Our community is becoming a destination. City residents access the former reformatory lands and visit businesses in the area. We need to invest in infrastructure to make the community safer and to make it attractive for future development. Let's make this a community to discover!

# Neighbourhood layout – East Guelph, within study area

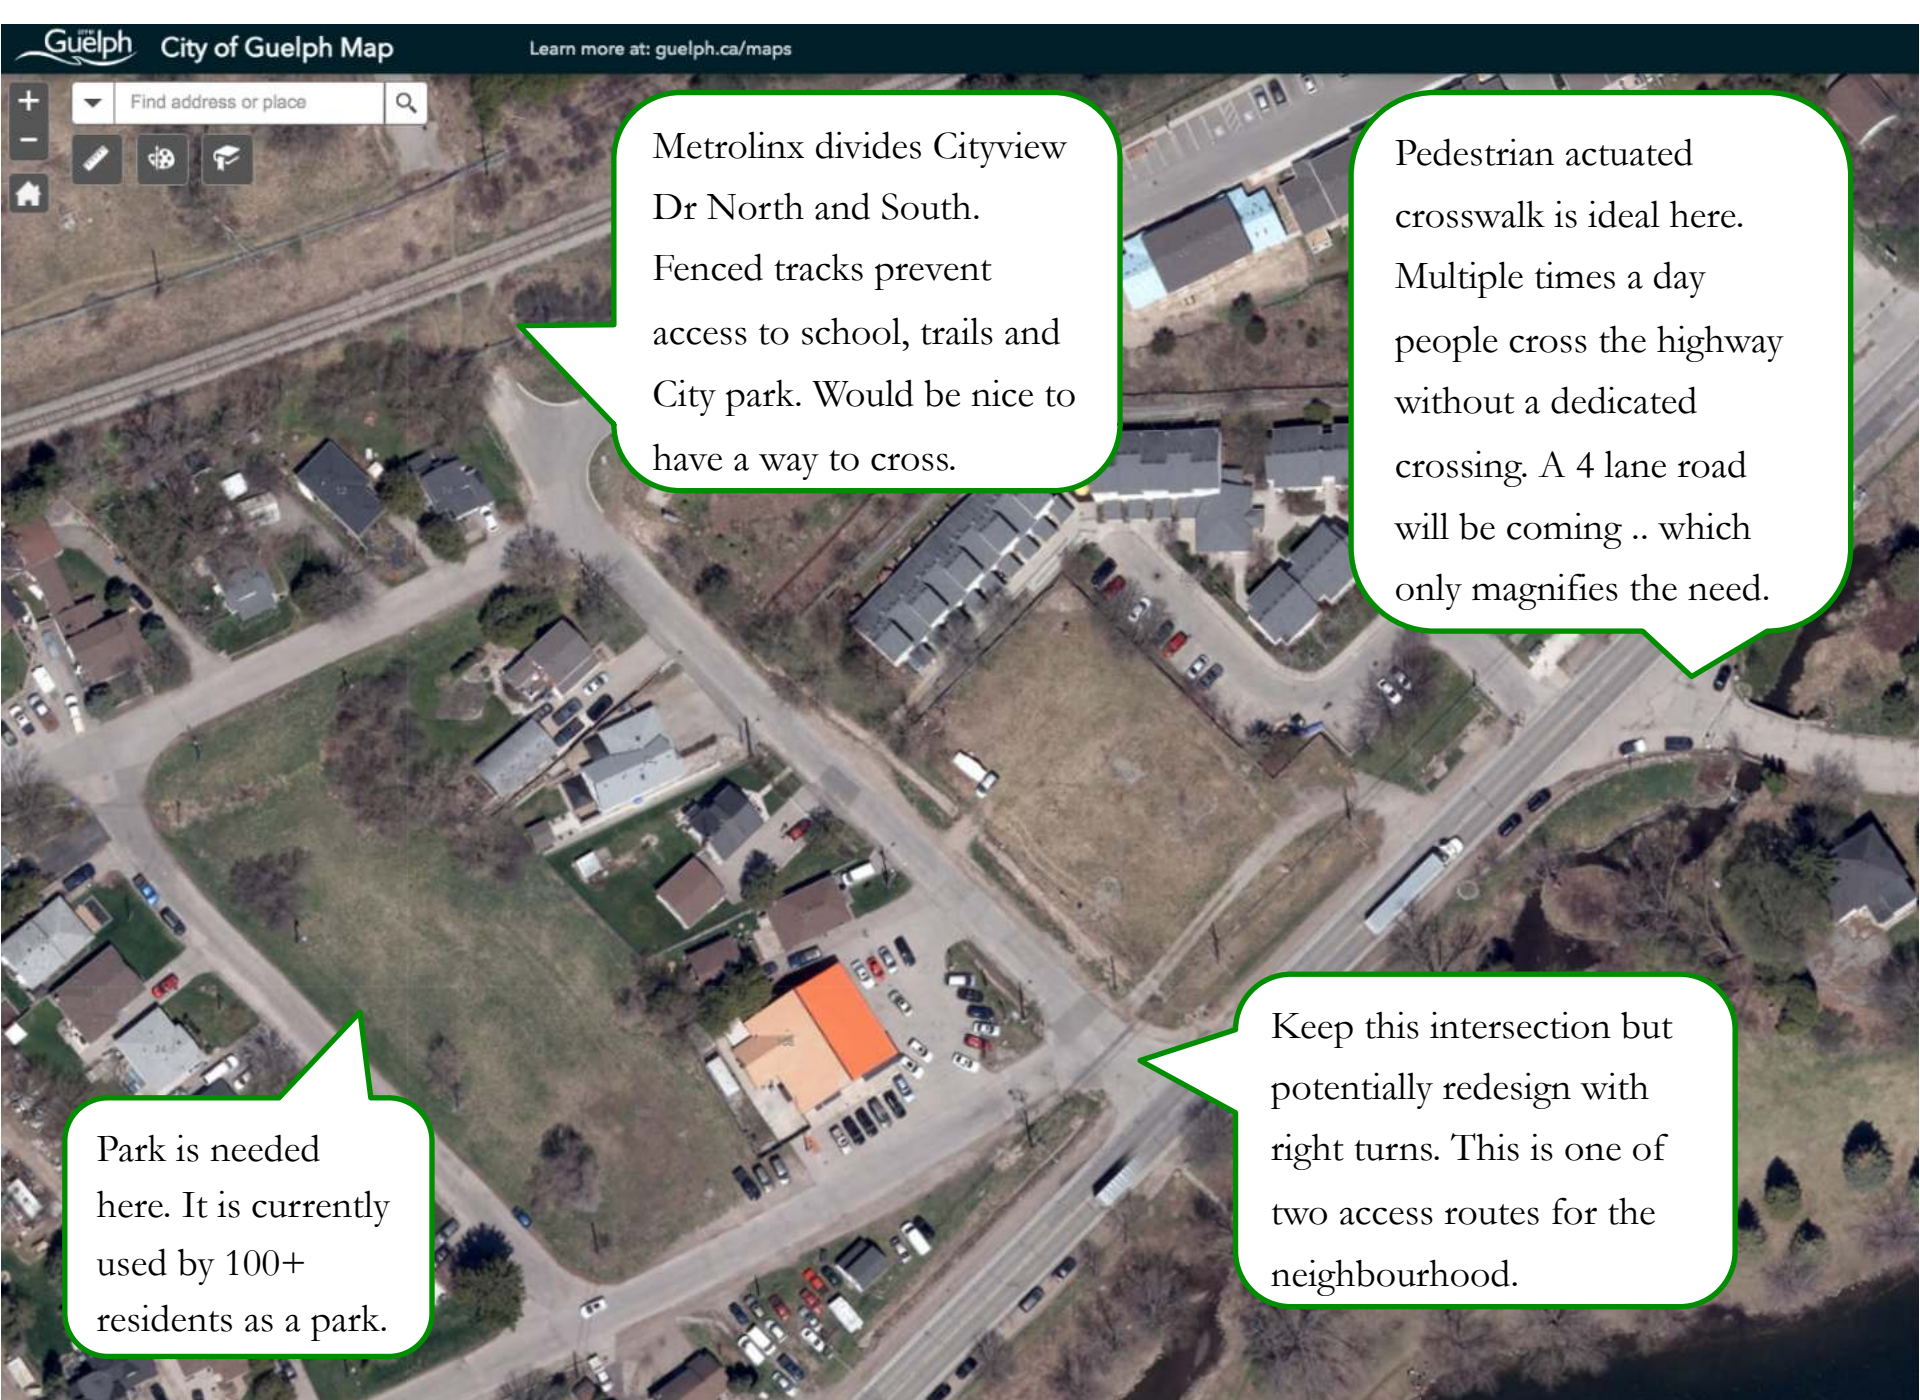
Within the study area there is a big contrast to what is present just north of the Metrolinx Rail line. There are sparse street trees, no stormwater areas, a lack of safe routes and no parks.

Metrolinx divides Cityview Dr North and South. Fenced tracks prevent access to school, trails and City park. Would be nice to have a way to cross.

Pedestrian actuated crosswalk is ideal here. Multiple times a day people cross the highway without a dedicated crossing. A 4 lane road will be coming .. which only magnifies the need.

Park is needed here. It is currently used by 100+ residents as a park.

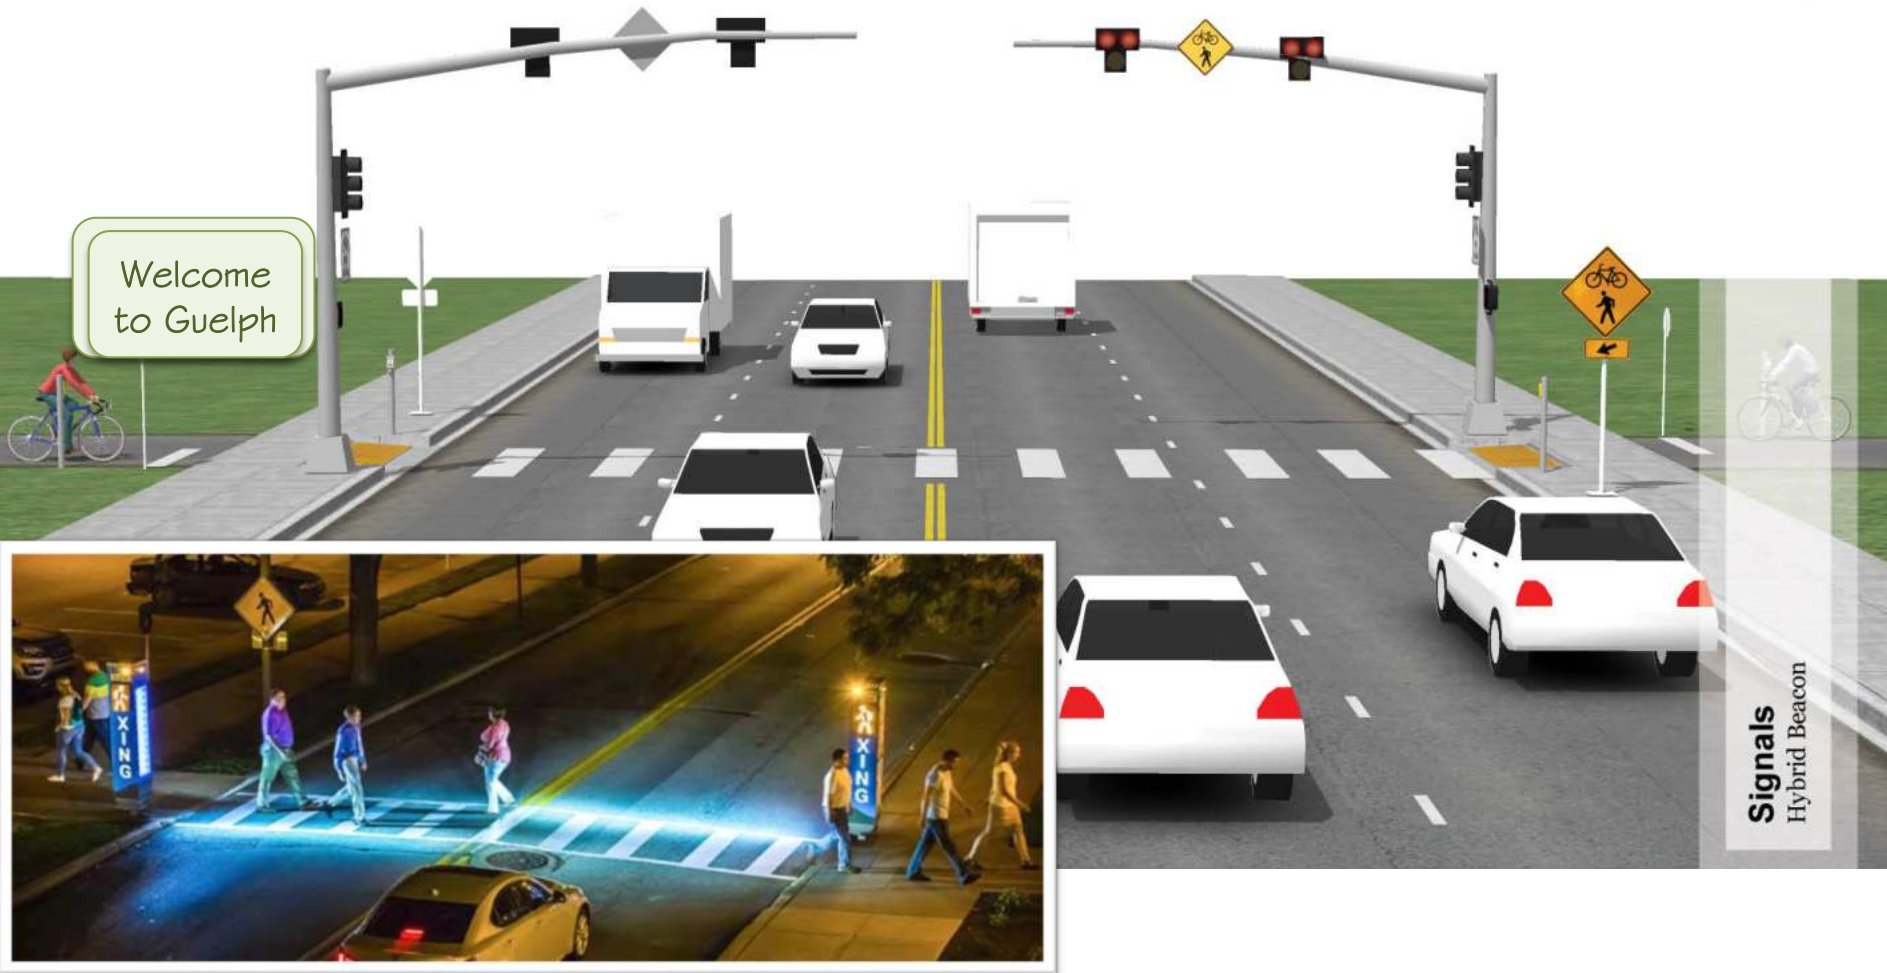
Keep this intersection but potentially redesign with right turns. This is one of two access routes for the neighbourhood.

Let's make safe and accessible routes a priority

Lack of dedicated sidewalks, bike paths and a pedestrian crossing is a detriment to this community. There is a plan for a 4 lane road – which magnifies the need for safe crossing.

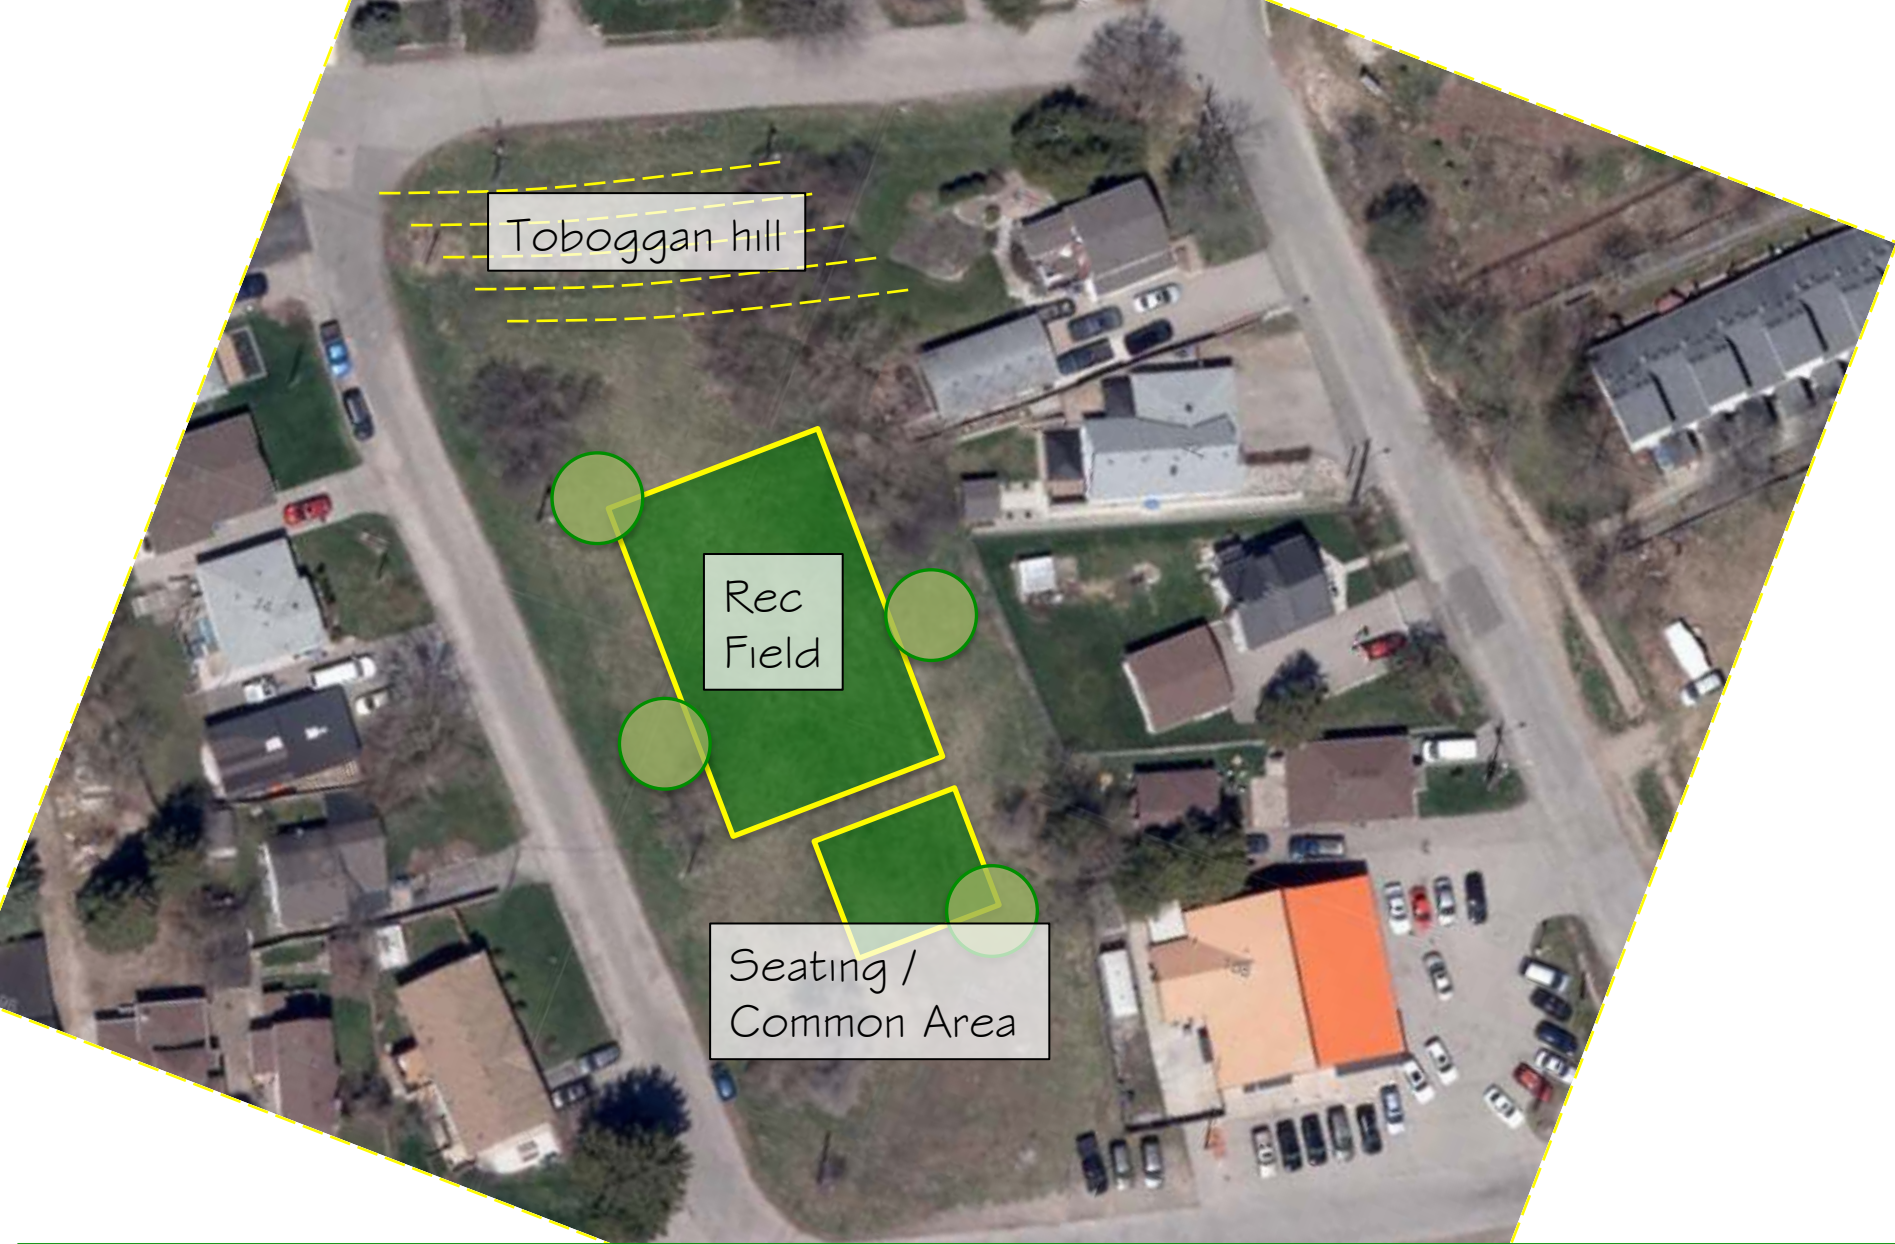
A neighbourhood park with a 40m by 30m rec field (6 by 6), the existing toboggan hill, a common area for seating / swings, and several shade trees. We need all this space dedicated for parkland.
